# A SUMMARY OF CUHP RE-CALIBRATION EFFORTS

September 2016

**Appendix C – Addressed Comments from June 2016 Draft Summary Report**

# RESPONSE TO COMMENTS FROM CUHP RECALIBRATION SUMMARY REPORT SENT IN JUNE OF 2016

Figure 17 - Frequency Curve for North Sanderson Gulch above Wadsworth

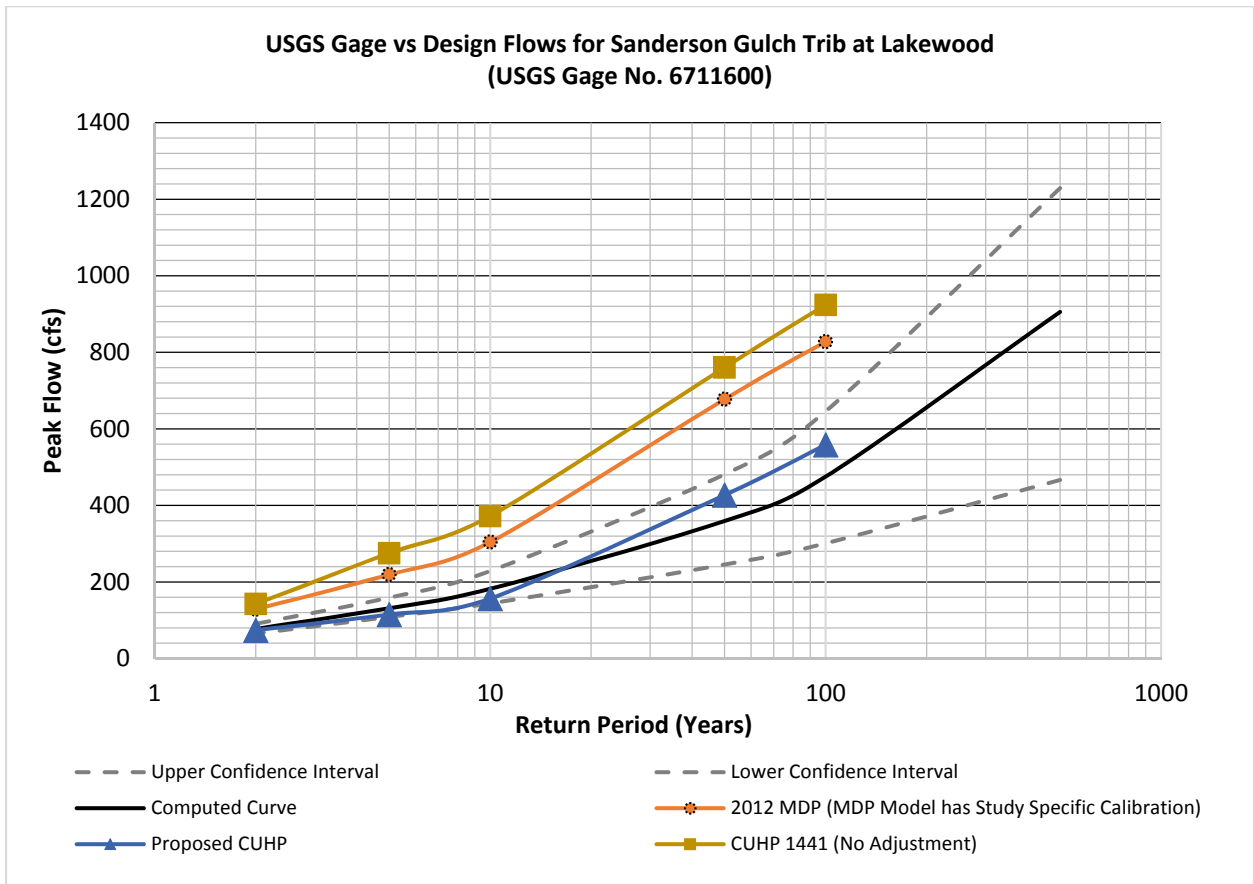
**Urbonas:** What I like to point out is that the North Sanderson Gulch data are very suspect. When we analyzed the data many years back, we found that it did not follow typical unit peak discharge trends. Upon field investigations, we found that the major storm sewer upstream of the gage had no stormwater inlets and that the flows at the upstream end of the catchment were greatly restricted by a culvert under a highway and detention storage. I do not know if any of these physical conditions were modified since, but these physical anomalies were there when data were taken.

**Response:** Thank you for pointing that out. I did not know that.

Figure 19 – Recorded and Predicted Hydrographs showing Hydrograph Timing

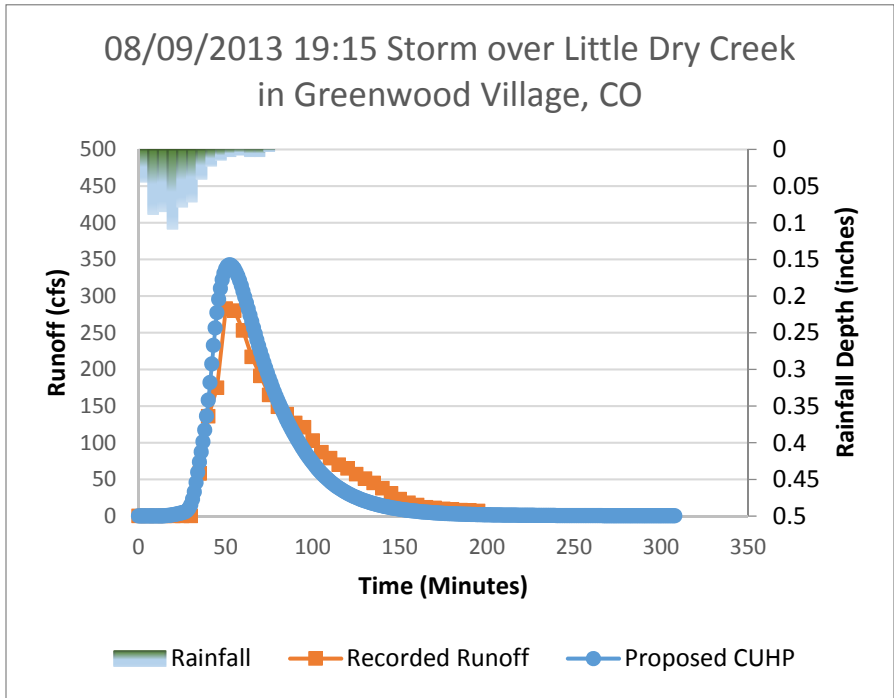
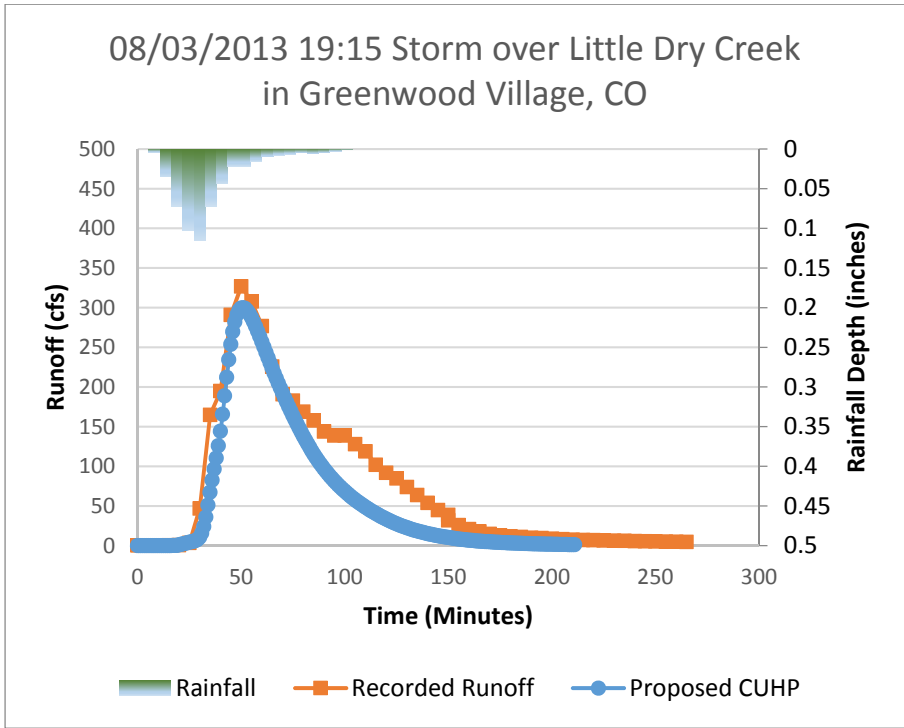
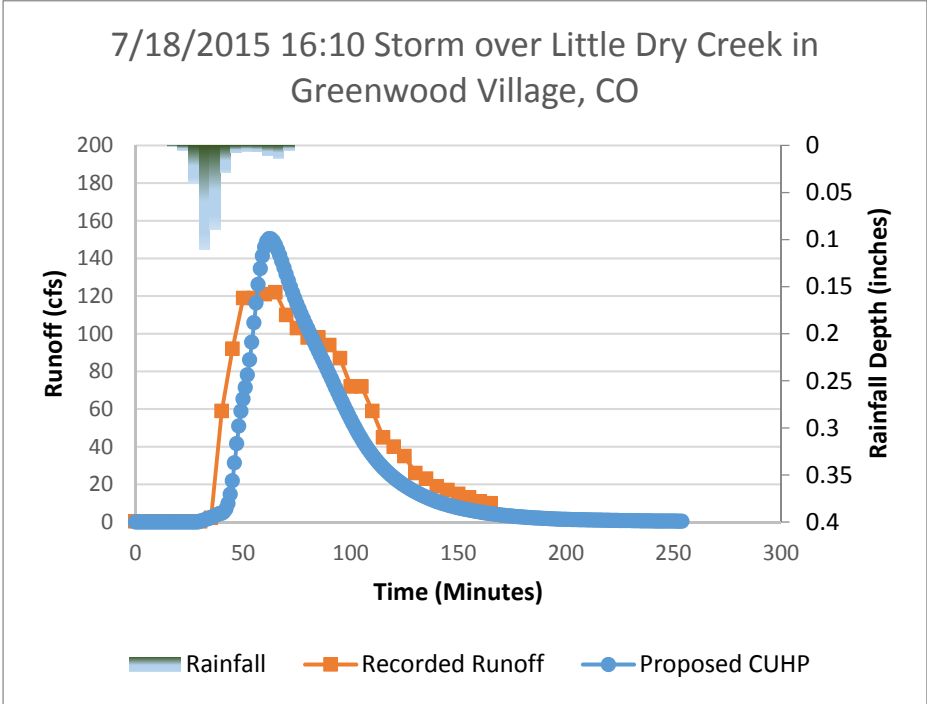
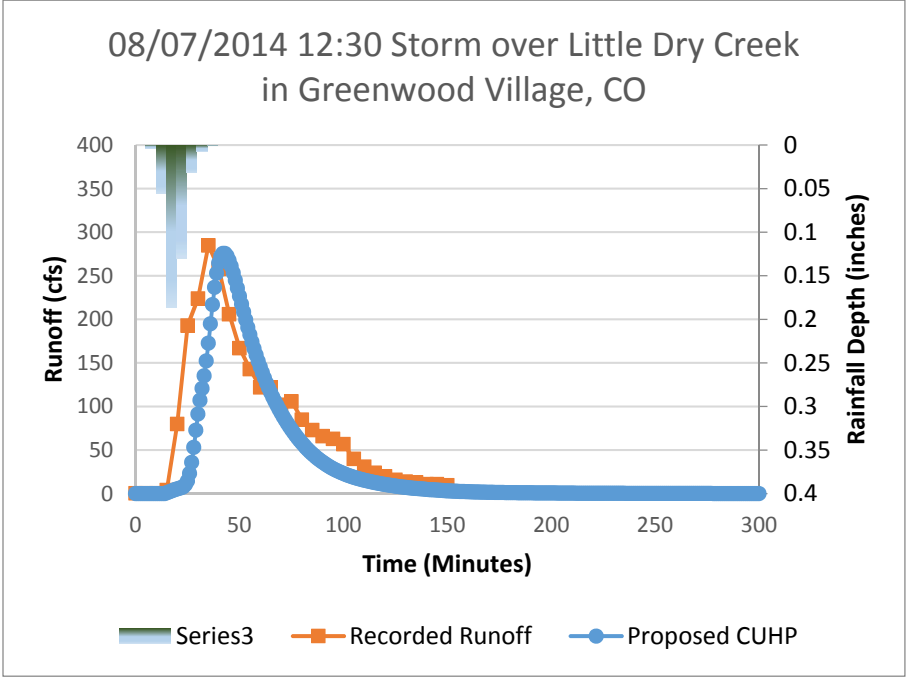
**Rapp:** The biggest concern with the re-calibration approach is that there does not appear to be any comparison of peak timing with the gage results. The modifications to the equations are changing the timing of the hydrograph peaks as well as the peak value. Plots should be created to show the outflow hydrographs from the existing and proposed CUHP/SWMM models and then compare those with the recorded stream gauge data to see how well the timing matches up. This will show what effect the reduced time to peak has in combination with the SWMM routing network.

**Response:** We have compared the timing and they match well. The Sept 2016 Version Addresses these comments.
